# UNITED STATES PATENT AND TRADEMARK OFFICE

APPLICATION NO.	FILING DATE	FIRST NAMED INVENTOR	ATTORNEY DOCKET NO.	CONFIRMATION NO.
10/072,872	02/12/2002	Yoshie Kanamori	100021-00069	2414

<b>Office Action Summary</b>	<b>Application No.</b>	<b>Applicant(s)</b>	
	10/072,872	KANAMORI ET AL.	
	<b>Examiner</b>	<b>Art Unit</b>	
	Long Nguyen	2816

## **DETAILED ACTION**

Fig.26

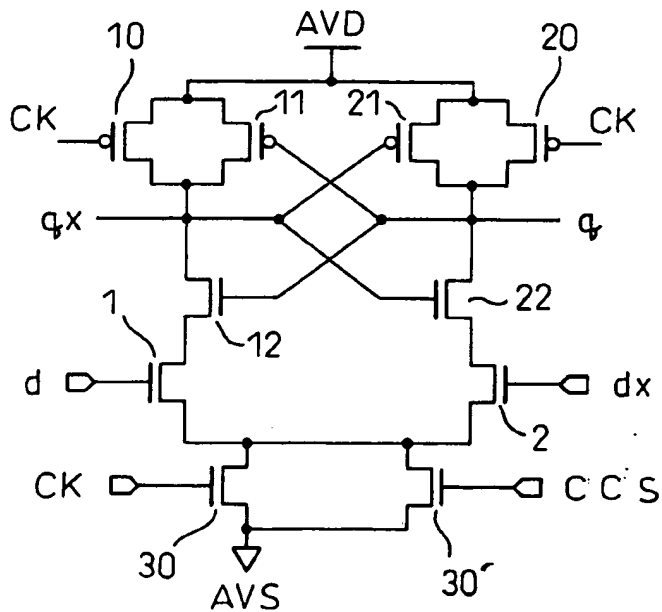
Not approved!  
Do not Enter!  
4/26/05 LW

Fig. 28

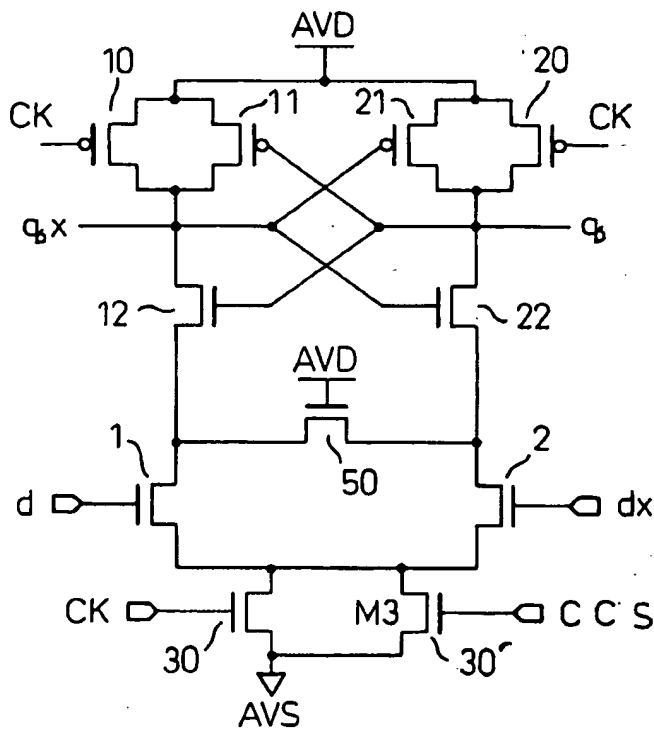
Not approved!  
Do not enter!  
4/26/05 LW

Not approved!  
Do not enter!  
4/26/05 W

Fig.29.

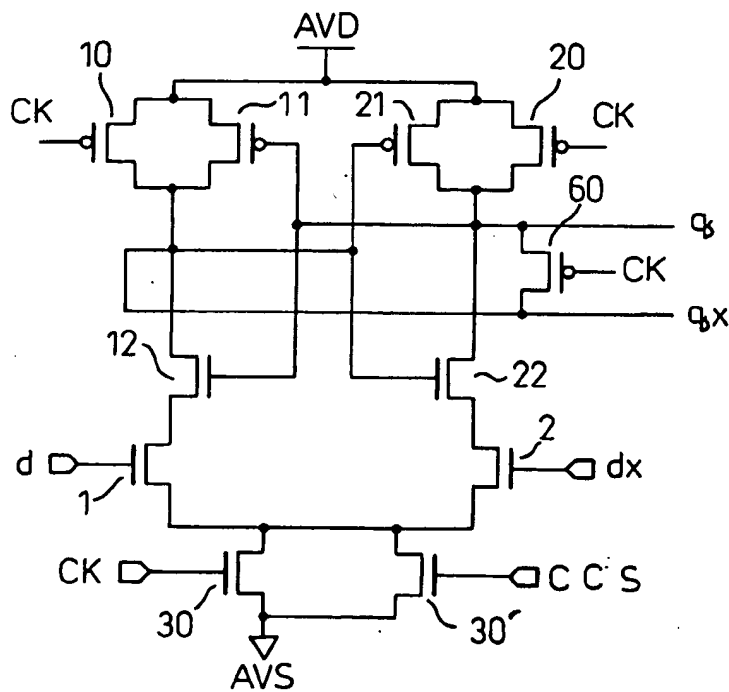
2. The amended to the specification filed on 3/21/05 is still objected to because the reaction "Fig. 29 is a circuit ... the invention;" on line 9-10 of page 2 of the amendment 3/21/05 is not line-through so the above recitation is not deleted and thus it still causes the new-matter's objection to the specification as discussed in the final office action mailed on 9/22/04. Appropriate correction is required.

Fig. 30

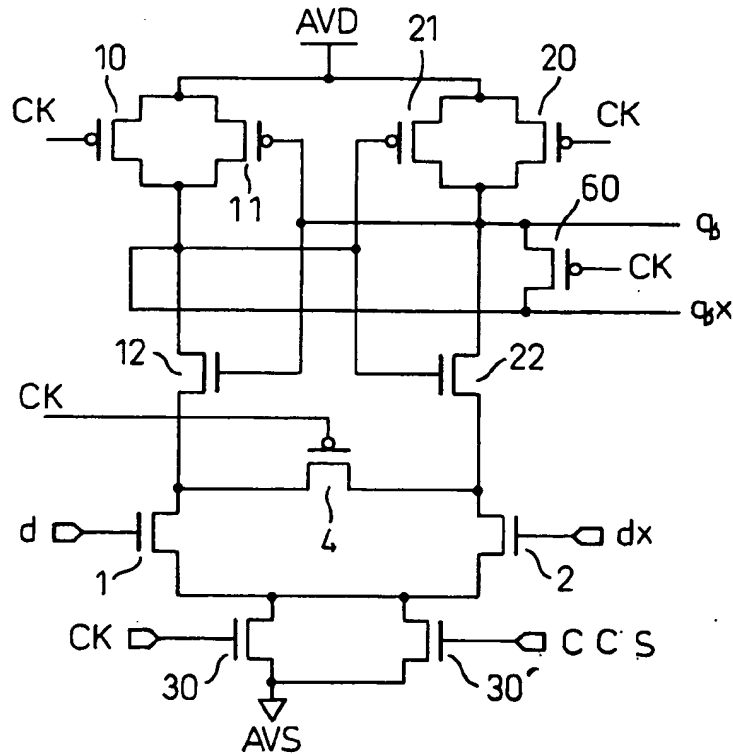
Not approved!  
Do not enter!  
24/26/05 2W
